North Eastern Regional Power Committee

Sub: 81वीं संरक्षण समन्वय उप-समिति (पीसीसी) बैठक का कार्यवृत्त/ Minutes of 81st Protection Coordination Sub-Committee (PCC) Meeting

81st Protection Coordination Sub-Committee Meeting

Date: 24/07/2025 (Thursday)

Event 2: Grid disturbance in Sanis, Wokha, Chiephebozou & Zadhima areas of Nagaland on 31-05-2025

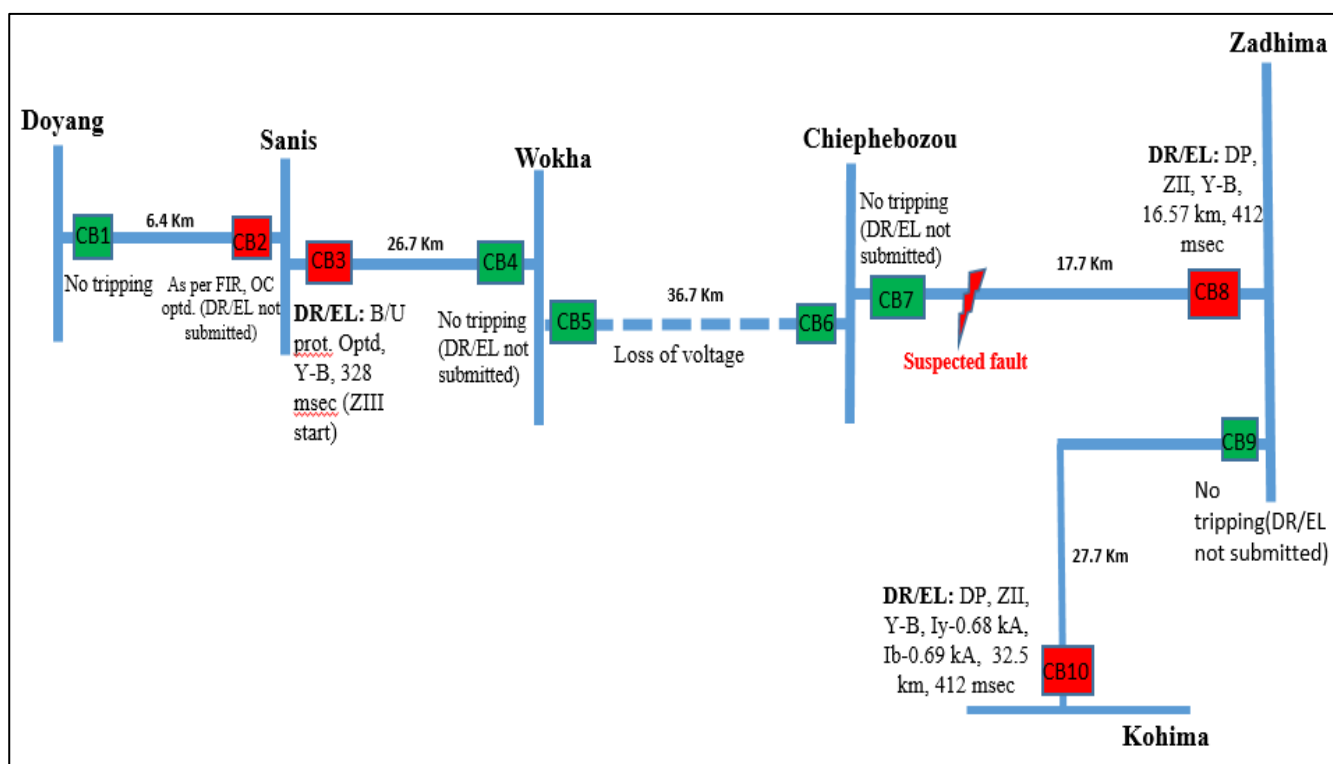
As per DR analysis, Y-B fault (Iy-0.68 kA, Ib-0.69 kA) initiated at 01:48:31.562 Hrs which was cleared within 412 msec from Kohima end on operation of DP, ZII. No tripping from Zadhima end.

DoP Nagaland may share the root cause of the event and provide update on the above-mentioned issues.

C.6 Grid Disturbance in Pasighat and radially connected Napit & Niglok areas of Arunachal Pradesh on 22-04-2025:

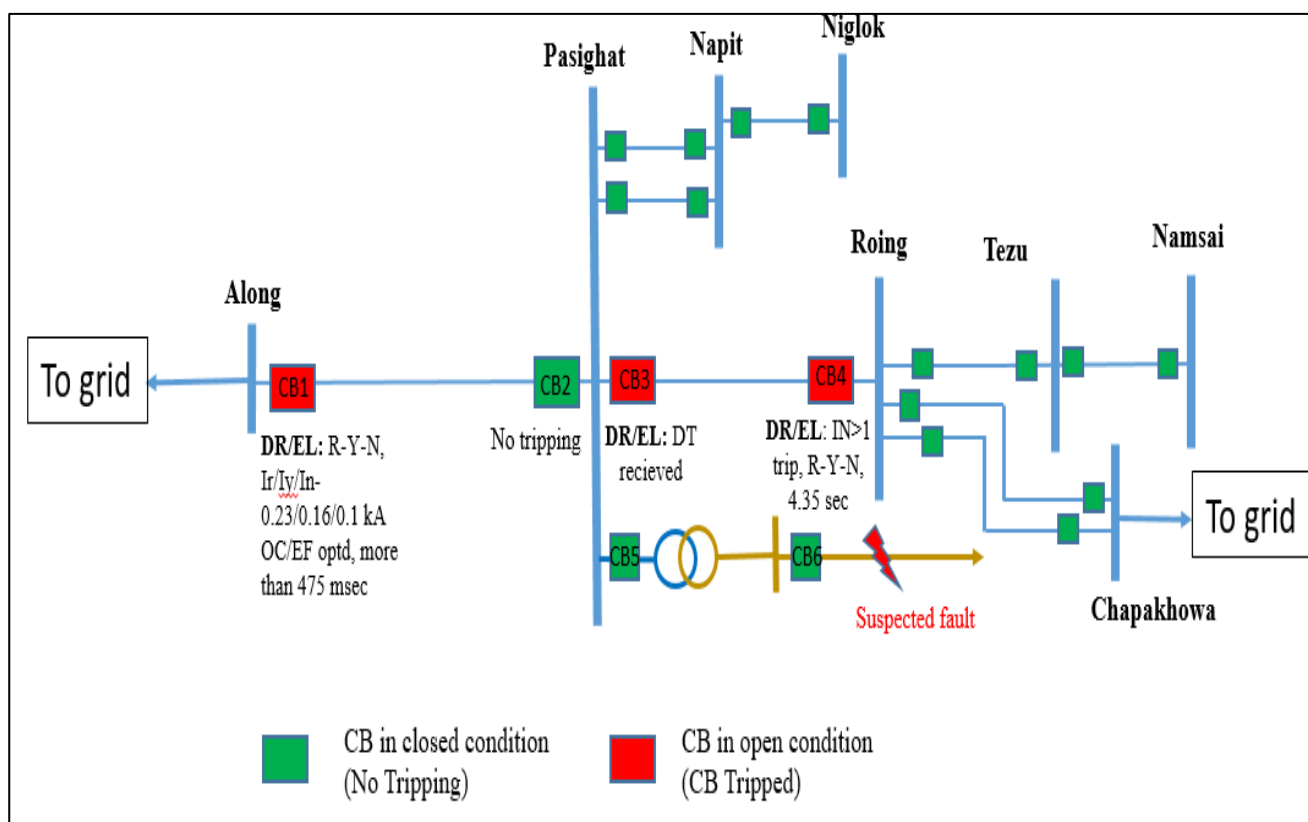
As per DR analysis, R-Y-N fault with Ir-237 A, Iy-167 A, In-107 A observed which was cleared in more than 475 msec from Along end on operation of OC/EF protection. No tripping from Pasighat end as per submitted DR. Fault duration recorded at Pasighat EL - 3.726 sec.

C.7 Grid disturbance in Churachandpur, Elangkankpokpi, Thanlon, Kakching, Chandel and Morey areas of Manipur and Tamu area Myanmar Power system on 28-04-2025:

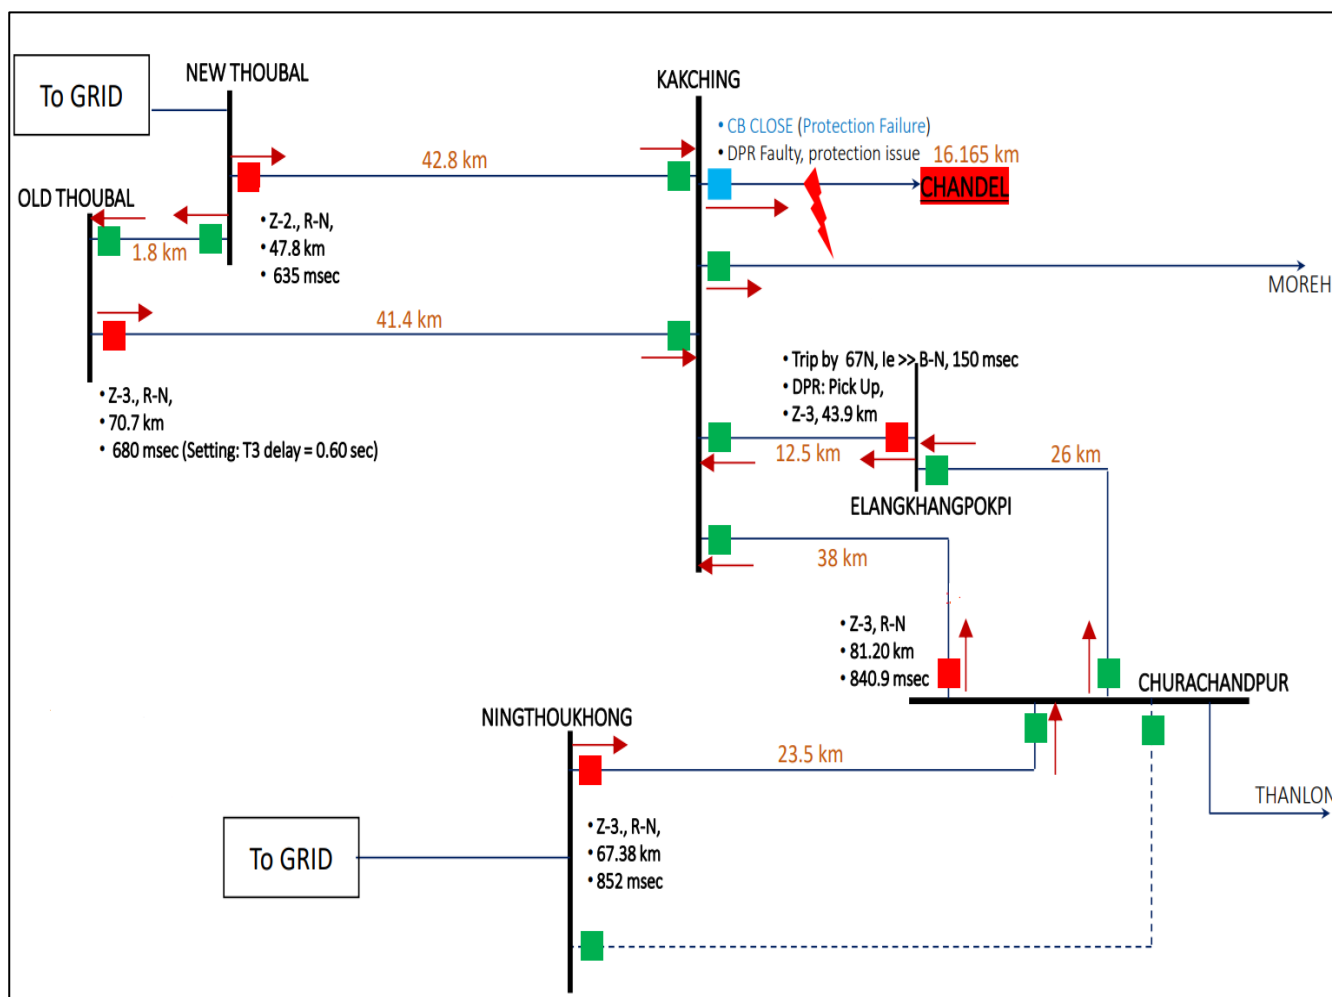
As per DR analysis of 132 kV Ningthoukhong-Churachandpur II Line, R-N fault (Ir-1.26 kA, In-1 kA) initiated at 13:42:32.292 Hrs which was cleared within 852 msec from Ningthoukhong end on operation of DP, ZIII.

Sl. No.	Observations	Remarks
1	Exact location of fault could not be concluded.	Vegetation fault was in 132 kV Kakching-Chandel Line
2	Protection system of 132 kV Kakching-Chandel line failed to isolate the fault.	Protection Circuit checked and distance relay replaced, settings and PSL tested.
3	132 kV New Thoubal-Kakching line tripped on ZII from New Thoubal end within 635 msec. ZII time delay needs to be revised as per protection philosophy.	Settings reviewed, will be updated once approved.
4	132 kV Old Thoubal-Kakching Line on ZIII from Old Thoubal end within 680 msec. ZIII time delay needs to be revised as per protection philosophy.	Settings reviewed, will be updated once approved.
